SUBJECT: ISSUANCE OF AMENDMENTS- JOSEPH M. FARLEY NUCLEAR PLANT,  
UNITS 1 AND 2 (TAC NO. M99610 AND M99612)

SUBJECT: ISSUANCE OF AMENDMENTS- JOSEPH M. FARLEY NUCLEAR PLANT,  
UNITS 1 AND 2 (TAC NO. M99610 AND M99612)

AMENDMENT TO FACILITY OPERATING LICENSE

SAFETY EVALUATION BY THE OFFICE OF NUCLEAR REACTOR REGULATION  
RELATED TO AMENDMENT NO. 132 TO FACILITY OPERATING LICENSE NO. NPF-2  
AND AMENDMENT NO. 124 TO FACILITY OPERATING LICENSE NO. NPF-8  
SOUTHERN NUCLEAR OPERATING COMPANY, INC., ET AL.  
JOSEPH M. FARLEY NUCLEAR PLANT, UNITS 1 AND 2  
DOCKET NOS. 50-348 AND 50-364

FIGURE 3.4-1

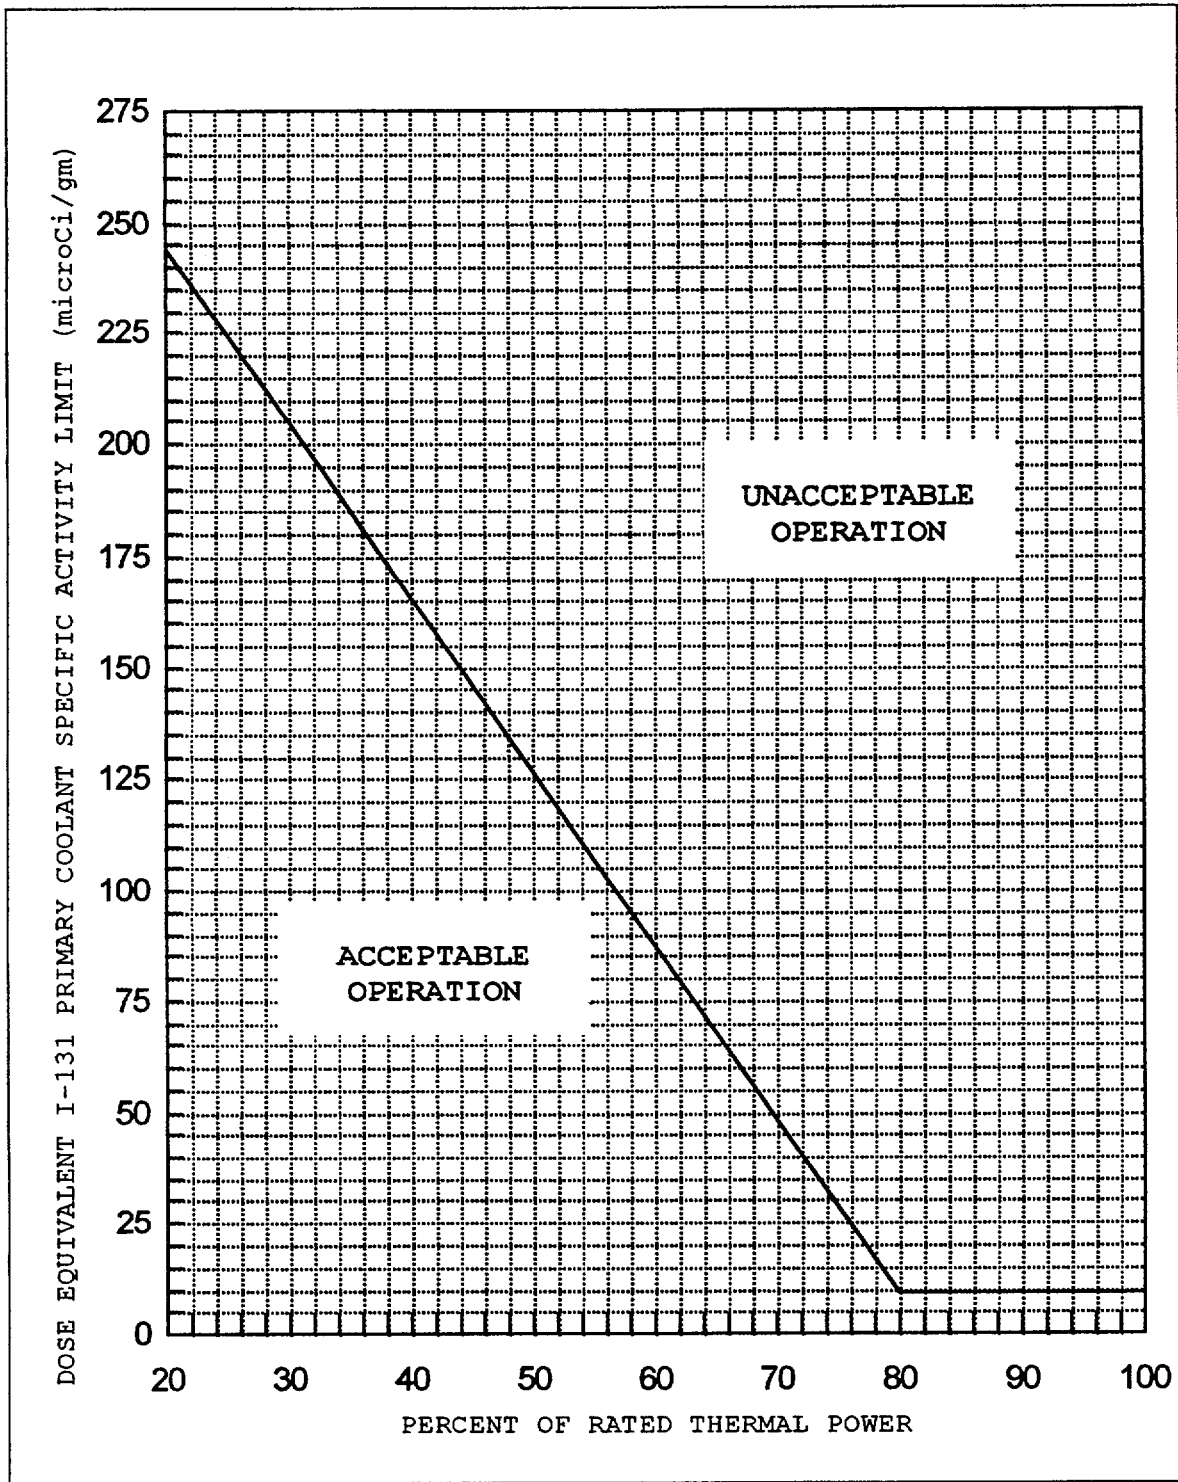
- a. With the specific activity of the primary coolant greater than 0.15 microCurie per gram DOSE EQUIVALENT I-131 for more than 48 hours during one continuous time interval or exceeding the limit line shown on Figure 3.4-1, be in at least HOT STANDBY with  $T_{avg}$  less than 500°F within 6 hours.
- b. With the specific activity of the primary coolant greater than  $100/\bar{E}$  microCurie per gram, be in at least HOT STANDBY with  $T_{avg}$  less than 500°F within 6 hours.

The ACTION statement permitting POWER OPERATION to continue for limited time periods with the primary coolant's specific activity greater than 0.15 microCuries/gram DOSE EQUIVALENT I-131, but within the allowable limit shown on Figure 3.4-1, accommodates possible iodine spiking phenomenon which may occur following changes in THERMAL POWER.

DOSE EQUIVALENT I-131 Primary Coolant Specific Activity Limit Versus Percent of RATED THERMAL POWER with the Primary Coolant Specific Activity > 0.15  $\mu\text{Ci}/\text{gram}$  Dose Equivalent I-131

FIGURE 3.4-1

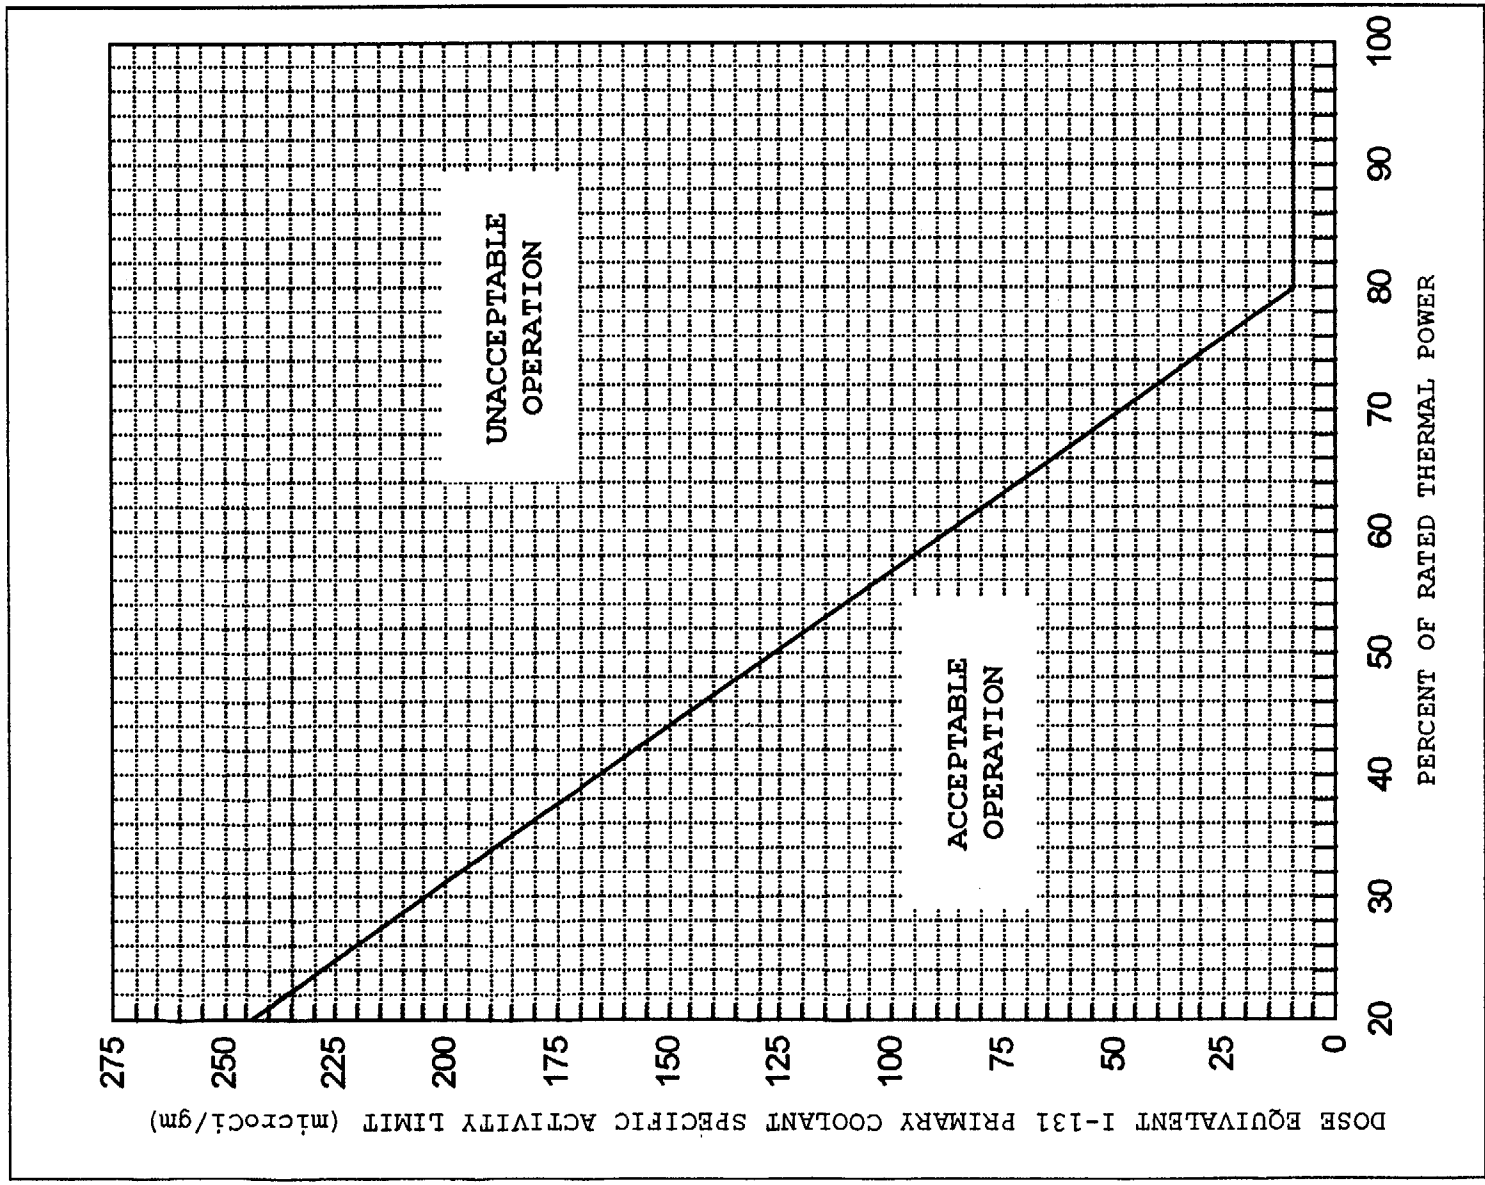
- a. With the specific activity of the primary coolant greater than 0.15 microCurie per gram DOSE EQUIVALENT I-131 for more than 48 hours during one continuous time interval or exceeding the limit shown on Figure 3.4-1, be in at least HOT STANDBY with  $T_{avg}$  less than 500°F within 6 hours.
- b. With the specific activity of the primary coolant greater than  $100/\bar{E}$  microCurie per gram, be in at least HOT STANDBY with  $T_{avg}$  less than 500°F within 6 hours.

The ACTION statement permitting POWER OPERATION to continue for limited time periods with the primary coolant's specific activity greater than 0.15 | microCuries/gram DOSE EQUIVALENT I-131, but within the allowable limit shown on Figure 3.4-1, accommodates possible iodine spiking phenomenon which may occur following changes in THERMAL POWER.

DOSE EQUIVALENT I-131 PRIMARY COOLANT SPECIFIC ACTIVITY LIMIT VERSUS  
 PERCENT OF RATED THERMAL POWER WITH THE PRIMARY COOLANT SPECIFIC  
 ACTIVITY > 0.15 μCi/gram DOSE EQUIVALENT I-131
